Memorandum

Re: Pilkington Road Plan Change – Clause 23 Request for Further Information (Landscape Visual

Assessment)

Figure 2: Viewpoint 6 Updated Location (source: Auckland Council GIS).

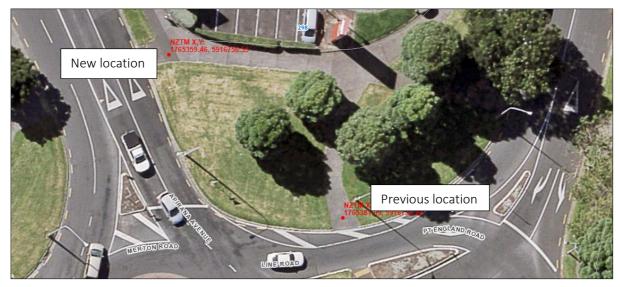
It should also be noted that the location of Viewpoint 6 has been amended to coordinates 1765359.46, 5916756.55. This amendment was undertaken to capture a more representative view of the site from the edge of Glen Innes Town Centre (refer figure 1).
